Hornsea Project Three
Offshore Wind Farm

Appendix 10 to Deadline 10 submission - Applicant's response to Natural England's Deadline 9 submission (Ornithology)

Date: 1st April 2019

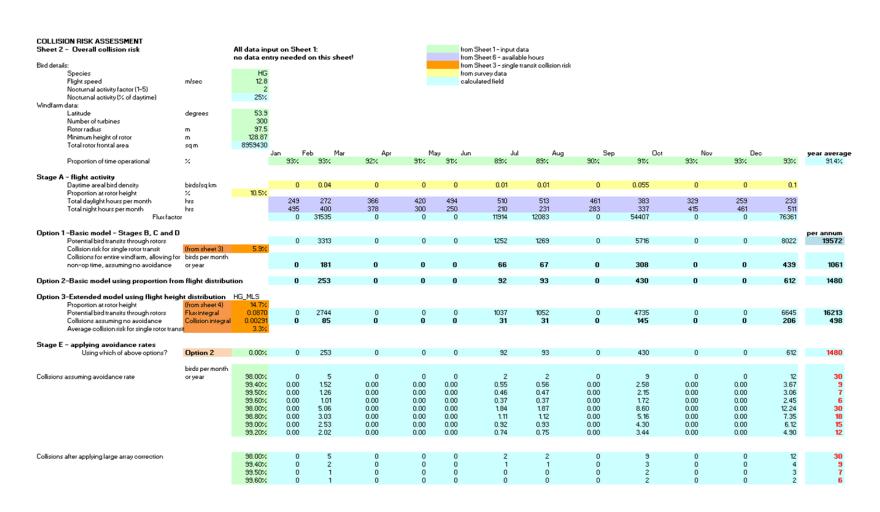
Figure 1.13 and Figure 1.23 contained minor errors in relation to the total columns presenting collision risk estimates. This was caused by the underlying formulas not incorporating those collision risk estimates calculated for December. This error does not affect any of the collision risk estimates presented throughout any other submissions. An updated version of Figure 1.13 and Figure 1.23 is presented in Figure 3.1 and Figure 3.2, respectively with red text identifying where values have changed.

Figure 3.3: Nocturnal activity factor entry in the Band (2012) CRM, Input Data spreadsheet (Method 1)

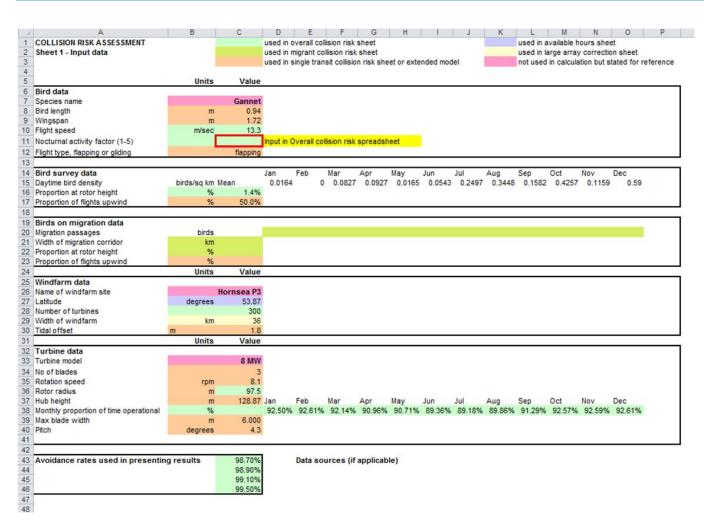
- Natural England have also suggested that errors exist in the collision risk spreadsheets presented in relation to the Applicant's position for gannet and kittiwake. The Applicant's position is that nocturnal activity factors from Furness et al. (2018) and MacArthur Green (2018) should be used to inform collision risk modelling. These nocturnal activity factors can be incorporated into the Band (2012) CRM in two ways. The first approach is to enter a value in cell C11 the Input Data spreadsheet (Figure 3.3) and the second is to enter the value in cell D7 of the Overall Collision Risk spreadsheet (Figure 3.4). These cells are highlighted in red in Figure 3.3 and Figure 3.4. The Applicant, in the spreadsheets presented in REP7-032 has used Method 2 and identified this using comments on Figures 1.16, 1.17, 1.18 and 1.19 in REP7-032 (highlighted in yellow in Figure 3.3). The Applicant has also highlighted that multiple nocturnal activity factors (representing the activity of birds in different seasons) are required to produce collision risk estimates with the relevant text highlighted in yellow in Figure 3.4. The Applicant rejects any notion that this may be misleading.

- If a nocturnal activity factor is entered in the Input Data spreadsheet, cell D7 of the Overall Collision Risk spreadsheet contains a formula that reads that value (='Input data'!C11). This is fundamentally no different to entering the value in cell C11 of the Overall Collision Risk spreadsheet. The Applicant explained the approach taken to incorporating seasonal nocturnal activity factors at Issue Specific Hearing 2 (5th December 2018).

Figure 3.5: Figure 1.18 as included in REP7-032 showing the input values for avoidance rate

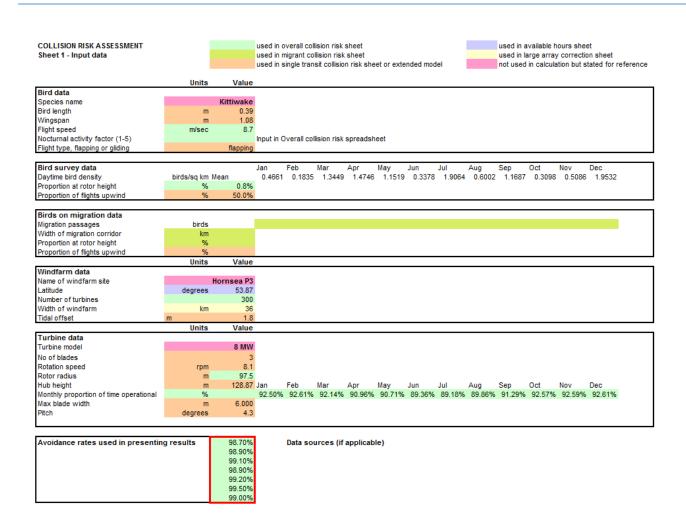
- 3.5 Natural England have also suggested that the avoidance rates presented in Figure 1.18 and Figure 1.19, which present the collision risk modelling spreadsheets used to calculate the collision risk estimates for kittiwake, do not match. Figure 3.5 and Figure 3.6 clearly show that the avoidance rates are identical unless Natural England are referring to collision risk estimates calculated when applying a large array correction. However, the Applicant has consistently stated in Written Representations (e.g. APP-109) and at Issue Specific Hearings (see REP6-010) that the large array correction factor has not been applied. Natural England are therefore incorrect on this point.
